**Regarding: 03V-309 Expansion of Recall**

## 2001~2003 XV16 MODELS FACTORY MODIFICATION CAMPAIGN

### 2002~2003 XV17PCP, PCPC, PCR, PCRC FACTORY MODIFICATION CAMPAIGN

### Main Shaft Modification:

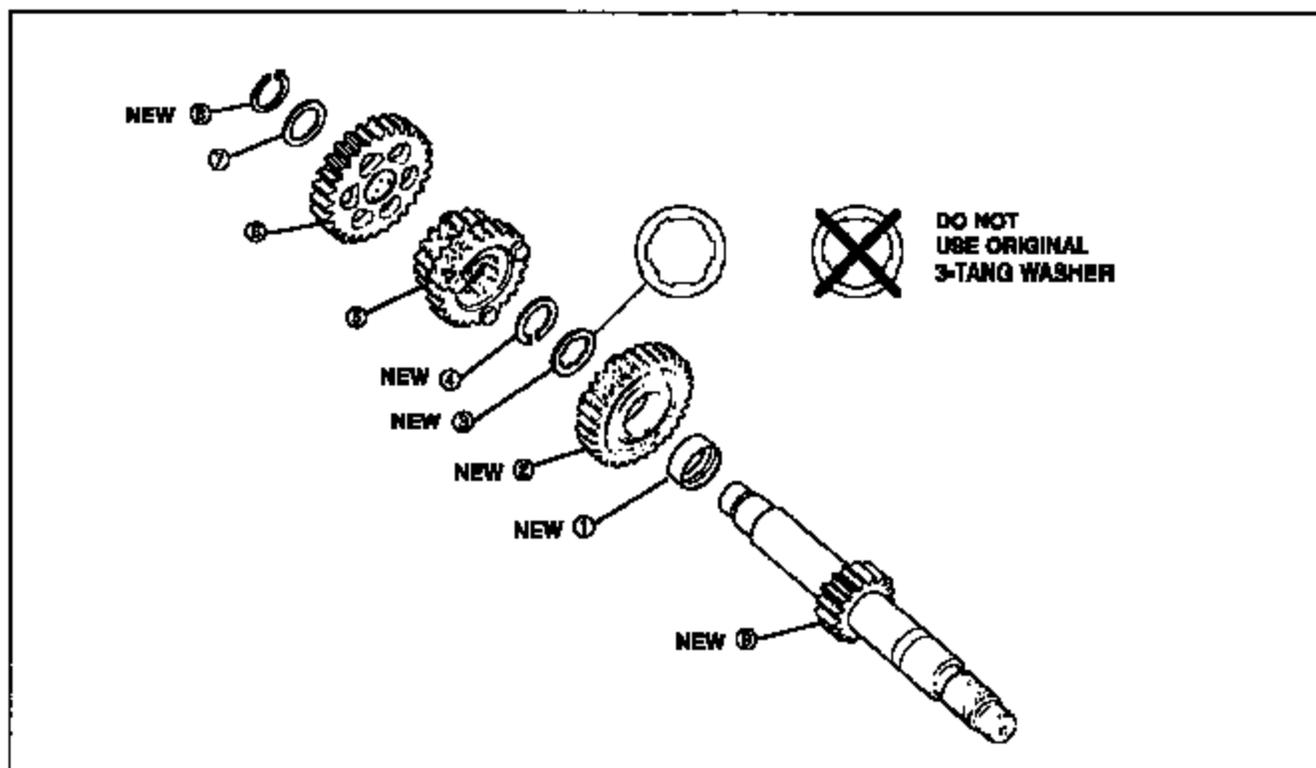
- Completely disassemble the main shaft. The Washer ⑦, 5th Pinion Gear ⑥, and 2nd/3rd Pinion Gear ⑤ will be reused.
- Install the components on the new-type Main Shaft ① in the following order. Lubricate all components with engine oil. Be sure circlips are installed with the sharp edge of the inner diameter facing away from the mating washer.

- ① Collar – NEW
- ② 4th Pinion Gear – NEW
- ③ Washer – NEW
- ④ Circlip – NEW
- ⑤ 2nd/3rd Pinion Gear – Reuse original part
- ⑥ 5th Pinion Gear – Reuse original part
- ⑦ Washer – Reuse original part
- ⑧ Circlip – NEW

Be sure to use all of the new parts in the kit. Otherwise, the transmission can still fail. Be sure that you are installing the new washer ③. It is thicker than the original and can be easily identified by its six tangs on the inner diameter instead of the three on the original washer.

### Drive Shaft Modification:

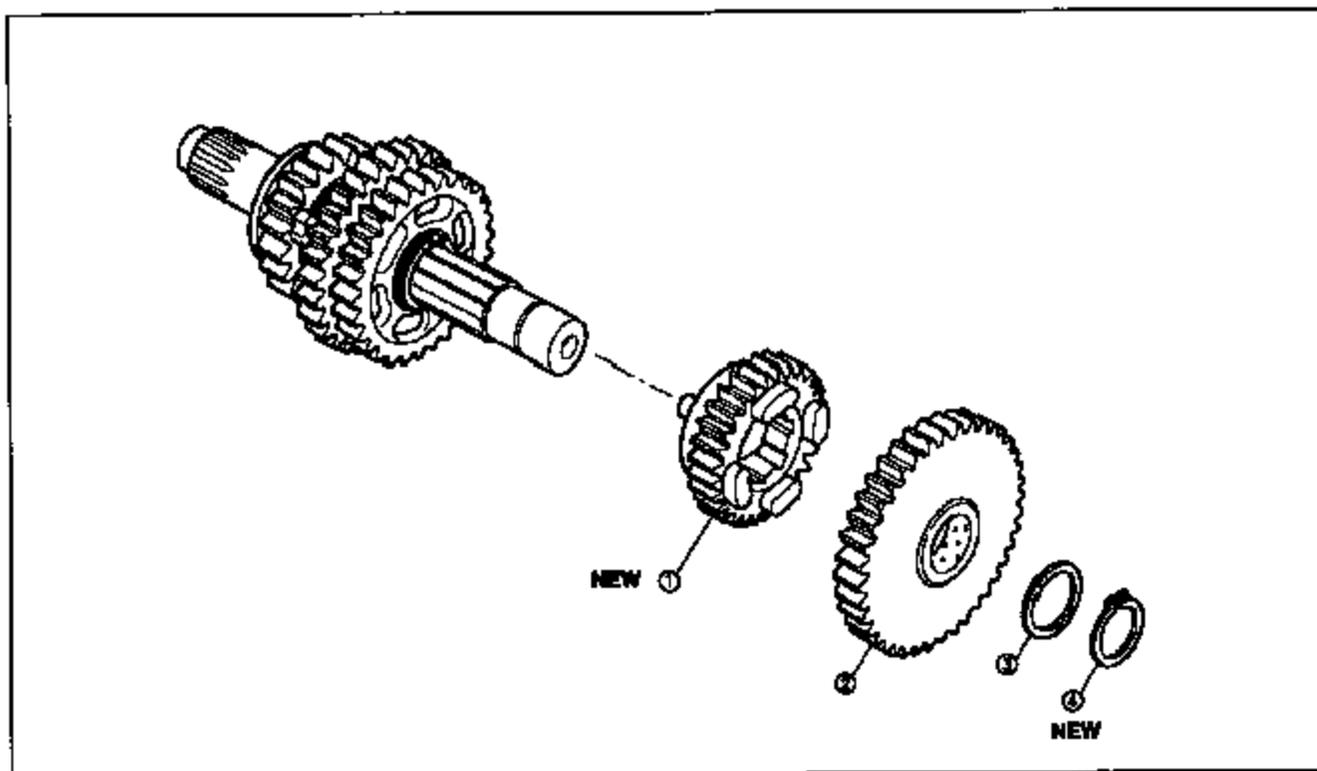
- Remove the circlip and washer from the Drive Shaft, then remove the 1st Wheel Gear and the 4th Wheel Gear. Do not disassemble the rest of the components on the shaft.
- Install the components on the original Drive Shaft in the following order. Lubricate all components with engine oil. Be sure the circlip is installed with the sharp edge of the inner diameter facing away from the mating washer.

- ① 4th Wheel Gear – NEW
- ② 1st Wheel Gear – Reuse original part
- ③ Washer – Reuse original part
- ④ Circlip – NEW

**Be sure to use all of the new parts in the kit. Otherwise, the transmission can still fail.**

### Main Shaft Modification:

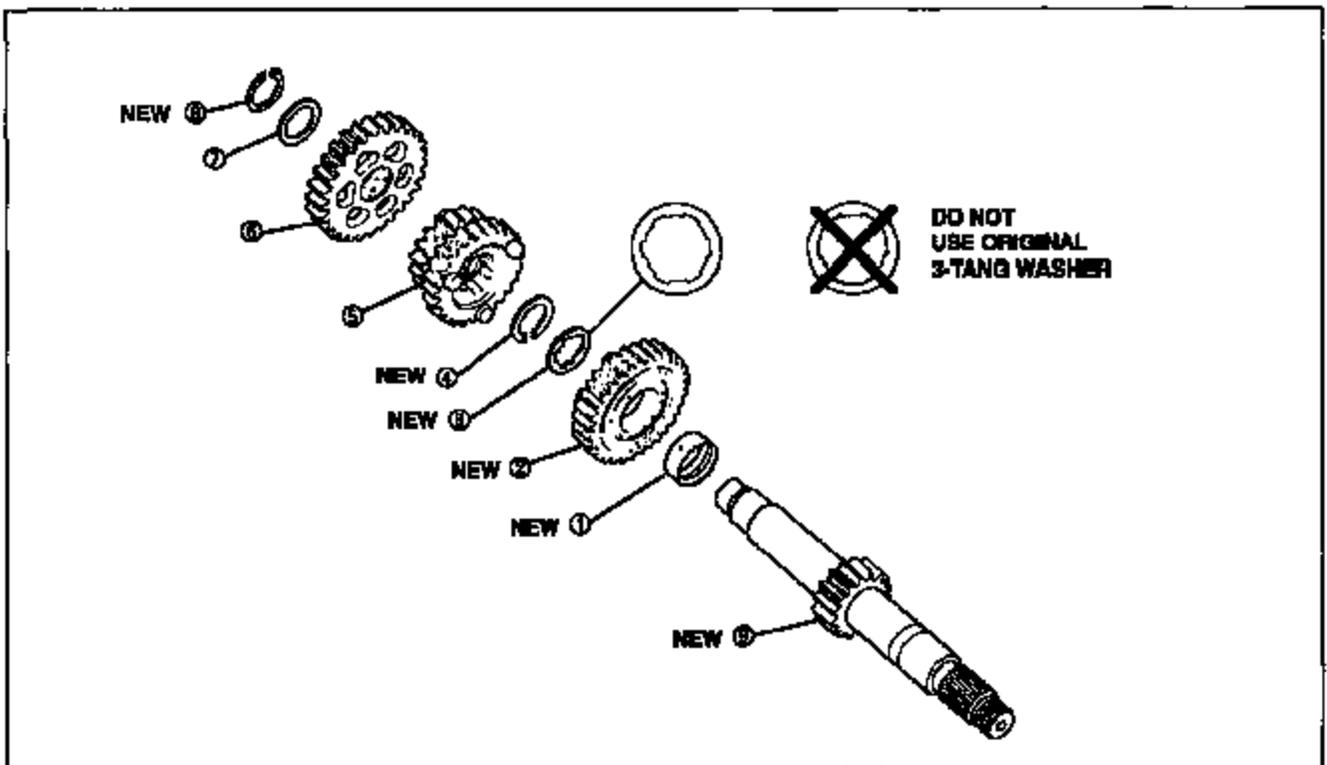
- Completely disassemble the main shaft. The Washer ⑦, 5th Pinion Gear ⑥, and 2nd/3rd Pinion Gear ⑤ will be reused.
- Install the components on the new-type Main Shaft ⑨ in the following order. Lubricate all components with engine oil. Be sure circlips are installed with the sharp edge of the inner diameter facing away from the mating washer.

- ① Collar – NEW
- ② 4th Pinion Gear – NEW
- ③ Washer – NEW
- ④ Circlip – NEW
- ⑤ 2nd/3rd Pinion Gear – Reuse original part
- ⑥ 5th Pinion Gear – Reuse original part
- ⑦ Washer – Reuse original part
- ⑧ Circlip – NEW

Be sure to use all of the new parts in the kit. Otherwise, the transmission can still fall. Be sure that you are installing the new washer ③. It is thicker than the original and can be easily identified by its six tangs on the inner diameter instead of the three on the original washer.

### Drive Shaft Modification:

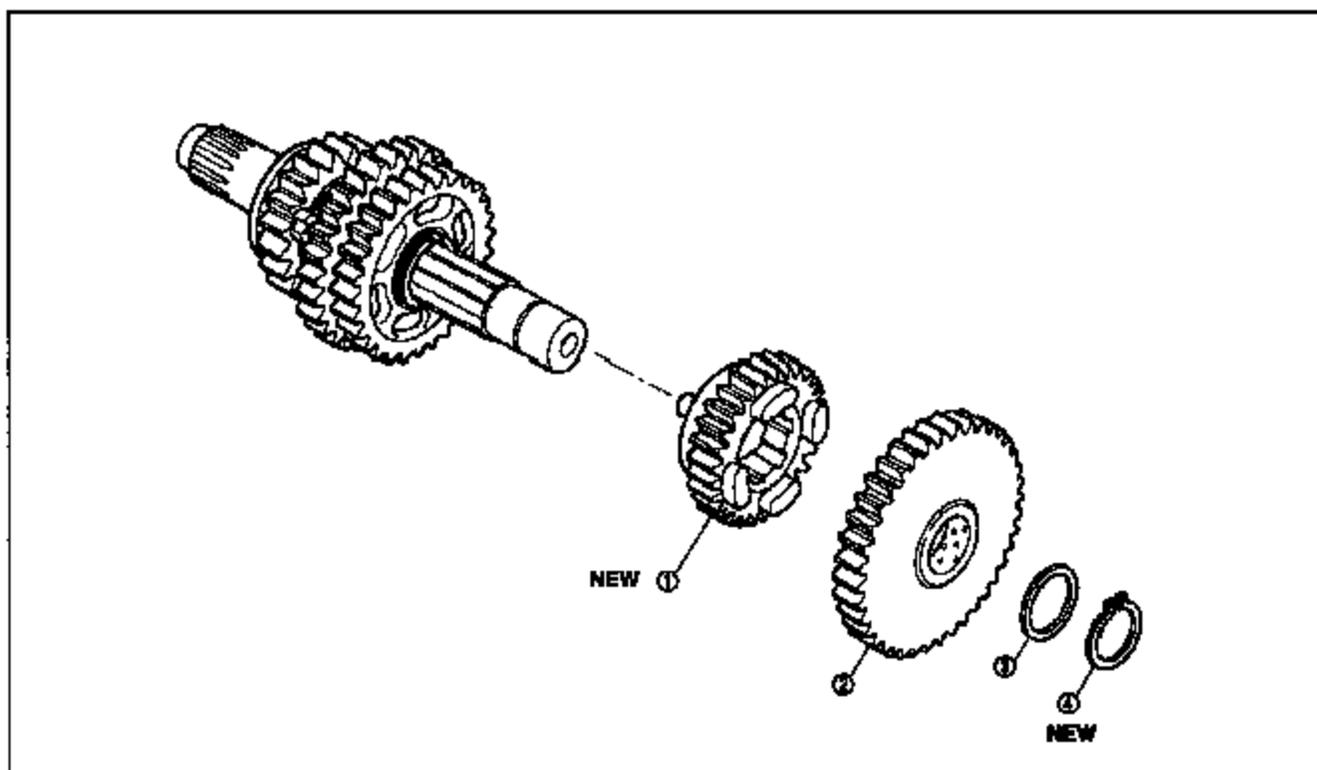
- Remove the circlip and washer from the Drive Shaft, then remove the 1st Wheel Gear and the 4th Wheel Gear. Do not disassemble the rest of the components on the shaft.
  - Install the components on the original Drive Shaft in the following order. Lubricate all components with engine oil. Be sure the circlip is installed with the sharp edge of the inner diameter facing away from the mating washer.
- ① 4th Wheel Gear – NEW
  - ② 1st Wheel Gear – Reuse original part
  - ③ Washer – Reuse original part
  - ④ Circlip – NEW

**Be sure to use all of the new parts in the kit. Otherwise, the transmission can still fail.**
